PRODUCT ADVISORY

Data Sheet Specification Correction for the Listed Intersil ISL6612E* and ISL6613E* EPSONIC Packaged Products

**Refer to:
PA10062**

Date: June 15, 2010

Incorrect POD – PA10062

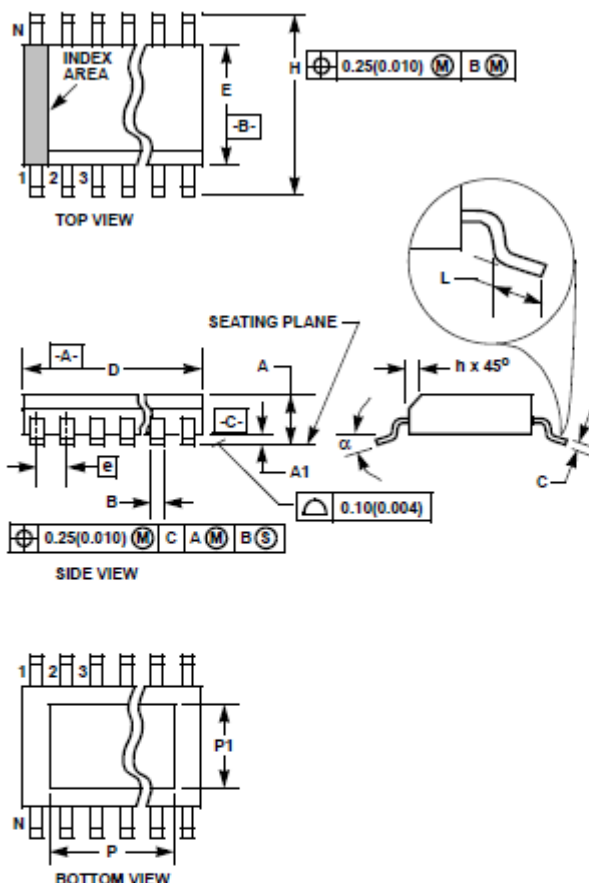
This advisory is to inform you that Intersil has made corrections to the POD (Package Outline Drawing) referenced in the data sheet specification for the listed Intersil ISL6612E* and ISL6613E* EPSONIC (Exposed Pad Small Outline Integrated Circuit) packaged products. The updates to the POD correct the package body width ("E") millimeter dimensions and change the controlling dimension from millimeter to inches in Note 10. There have been no changes made to the package or product itself. The updated data sheet incorporating the corrected POD is available on the Intersil web site at <http://www.intersil.com/data/fn/fn9153.pdf>.
